Sea Plane quartz 24582 = 25582
 Sea Plane chronograph 24075 = 25075
 Sea Plane XL mechanical 24076 = 25076.

The modification has been done to avoid the bracelet slippery around the case.

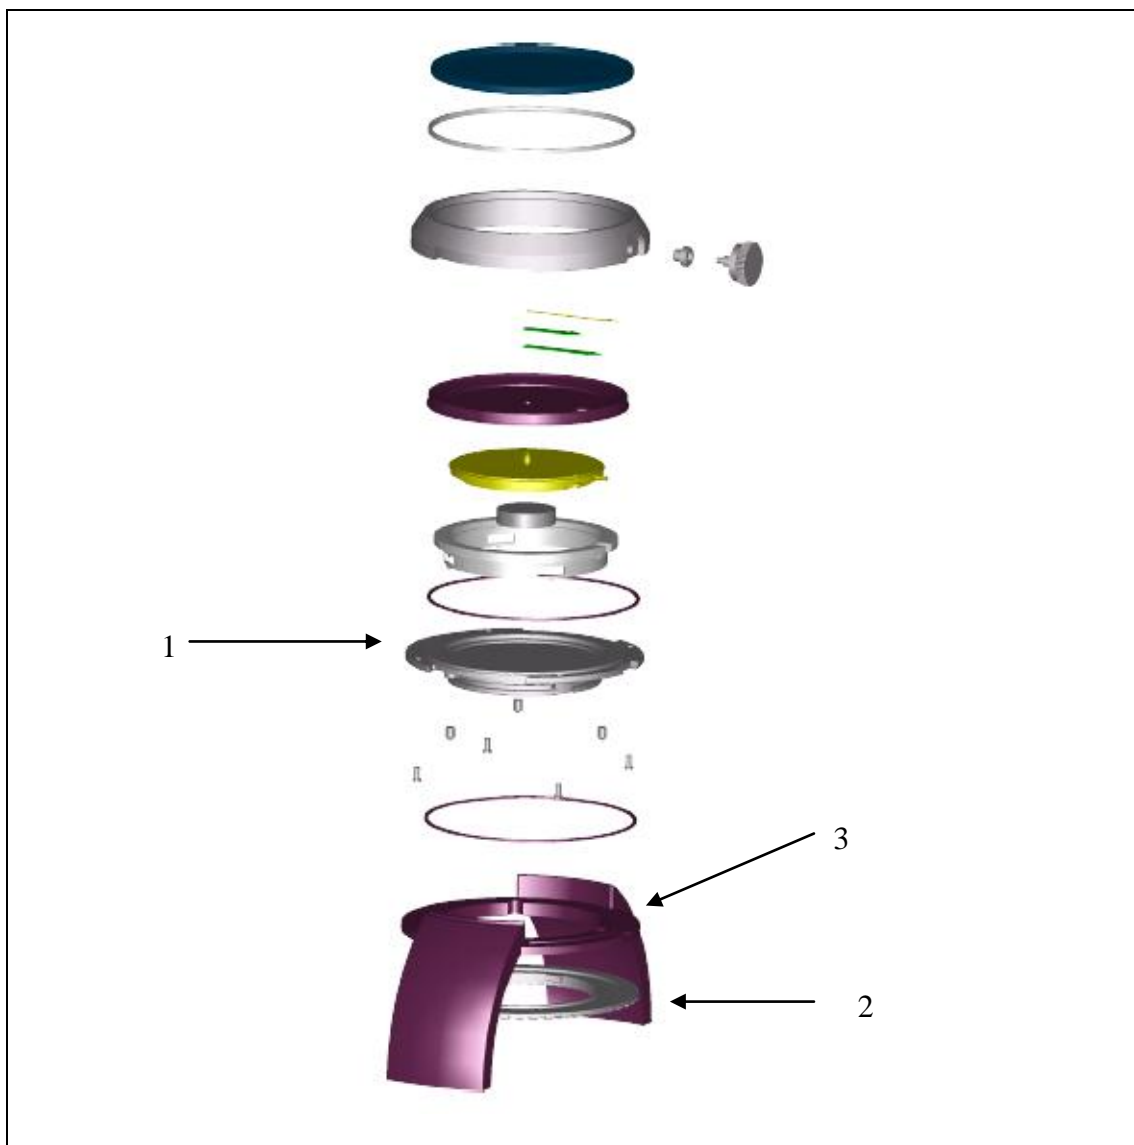
The following parts are modified:

- 1- The back case (3 posts with push piece had been added)
- 2- The locking ring (3 blind holes which work with the back case push piece)
- 3- The bracelet / leather strap / rubber band (3 notches had been cut on the diameter)
